**Development
Application
Permit
Review**

Name:	The Estates at Cathedral Pines	Application Type:	Final Plat
PCD Reference #:	SF2234	Total Acreage:	35.00
		Total # of Dwelling Units:	8
Applicant / Owner:	Owner's Representative:	Dwelling Units Per 2.5 Acres:	0.57
Villagree Development Corp	William Guman & Associates	Regional Park Area:	2
5710 Vessey Rd	731 North Weber St	Urban Park Area:	2
	Suite 10	Existing Zoning Code:	RR5
Colorado Springs, CO 80908	Colorado Springs, CO 80903	Proposed Zoning Code:	PUD

The Estates at Cathedral Pines

CATHEDRAL PINES SUBDIVISION FILING NO. 9

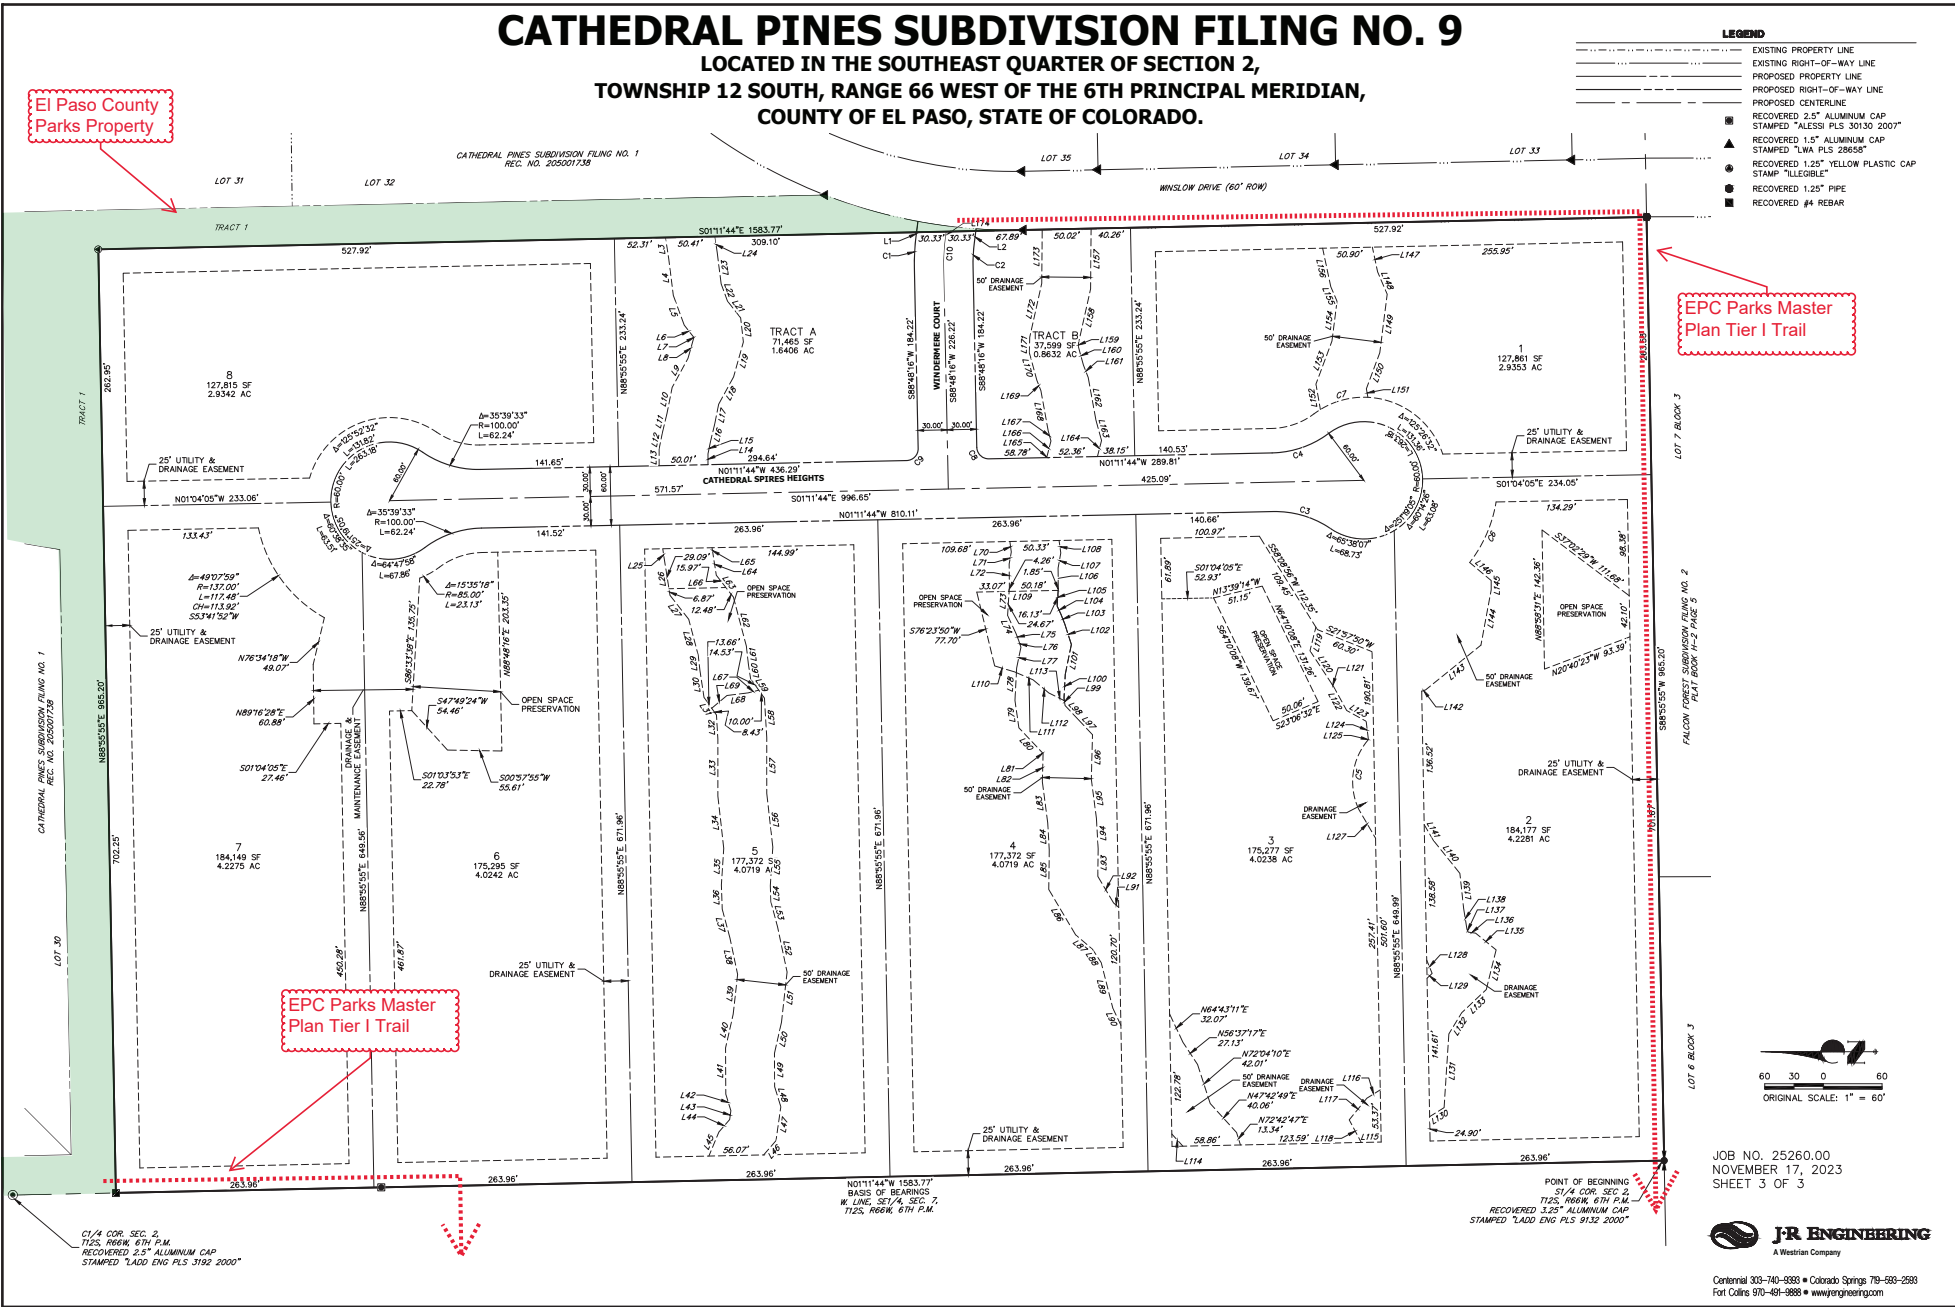
EPC Parks Master
Plan Tier I Trail

EPC Parks Master
Plan Tier I Trail

ESTATES AT CATHEDRAL PINES
 SIGNAGE AND STRIPING PLAN

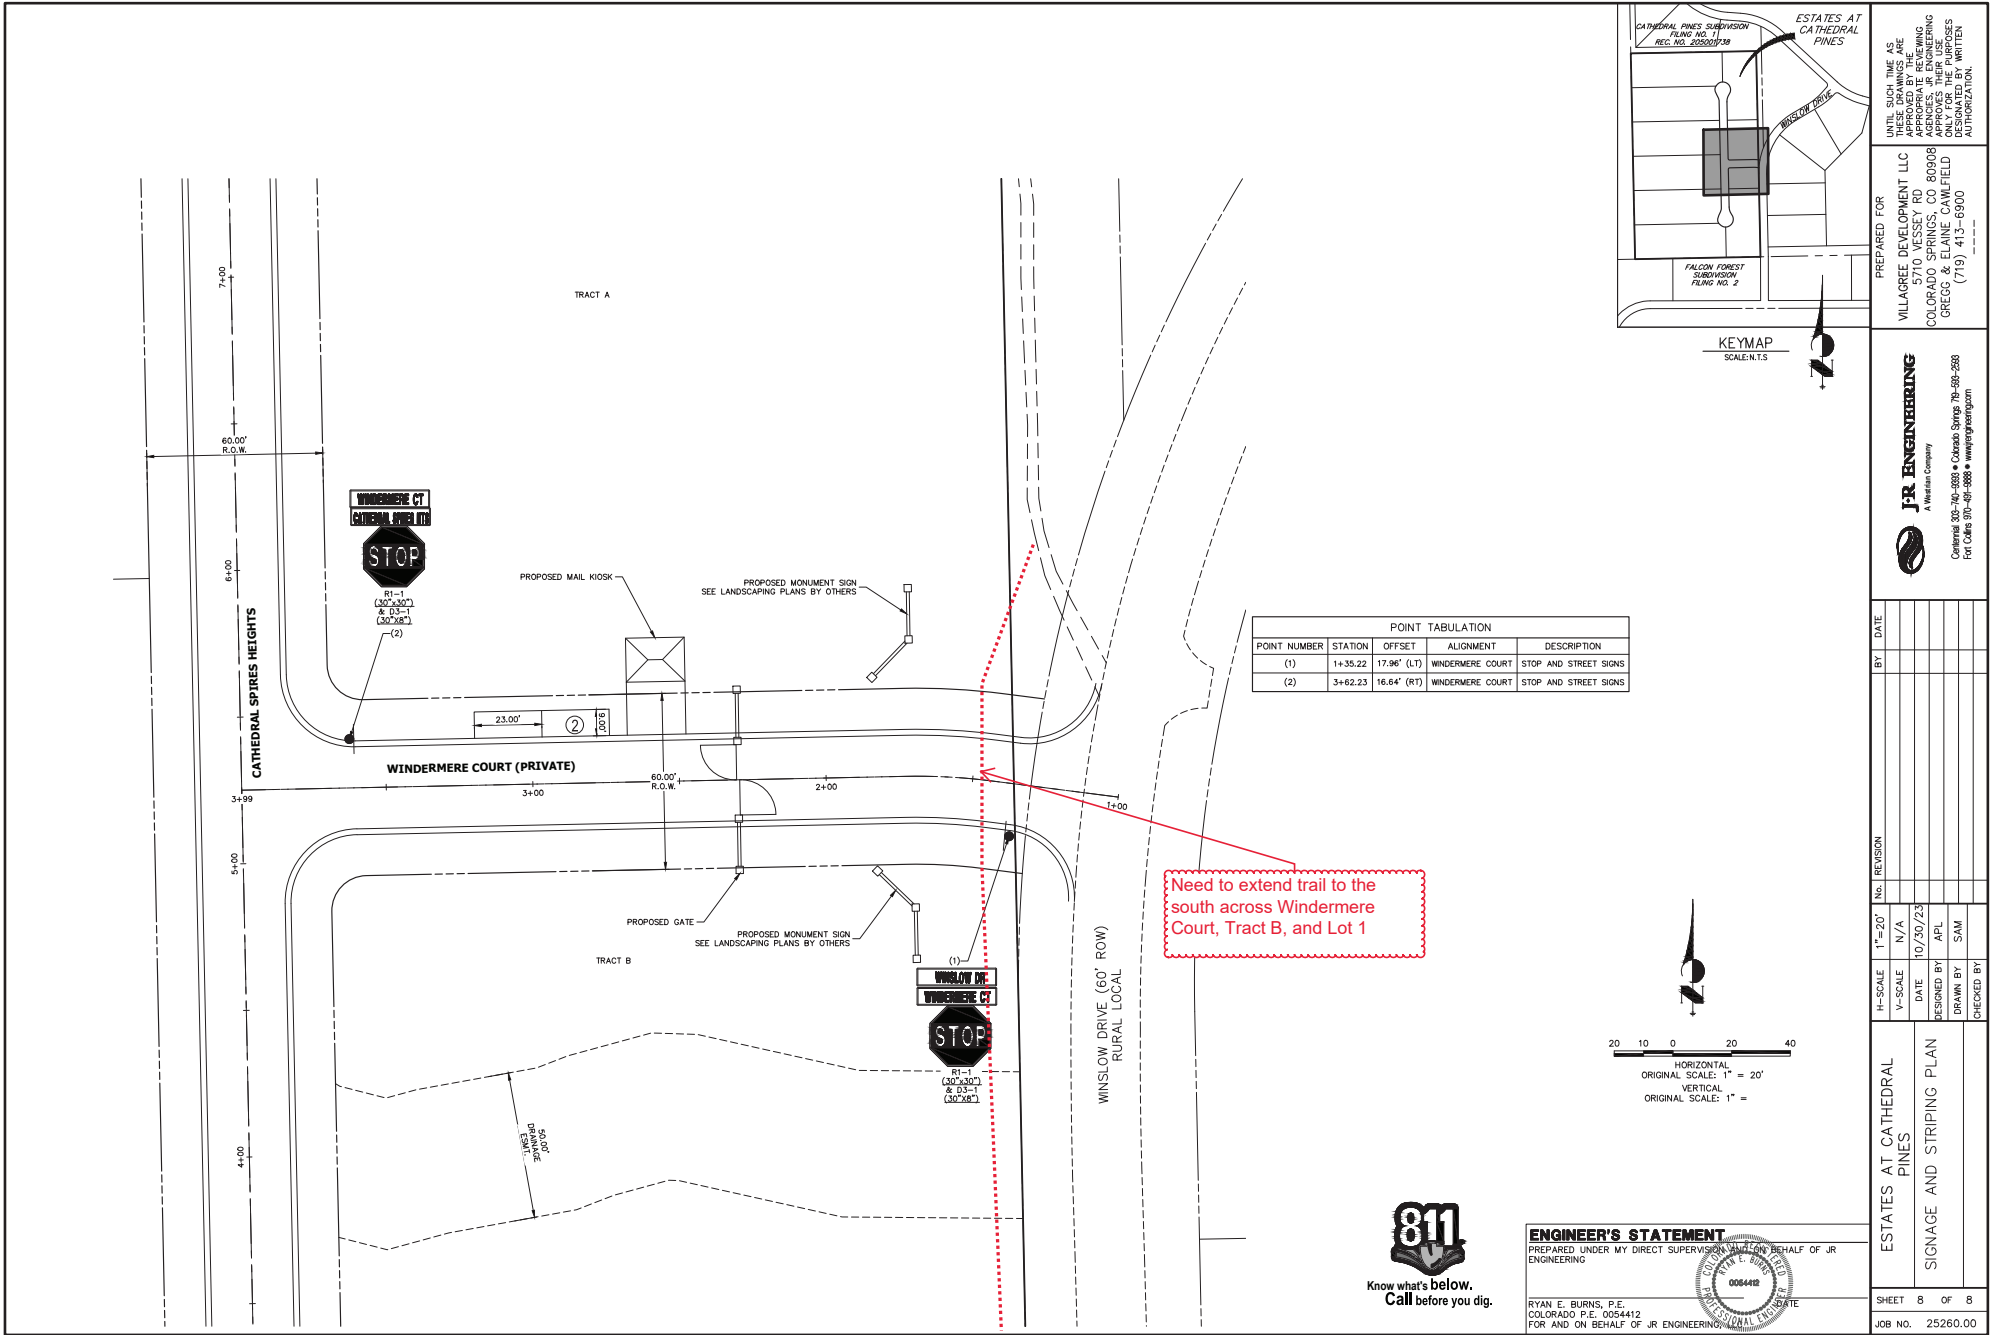
Need to extend trail to the south across Windermere Court, Tract B, and Lot 1
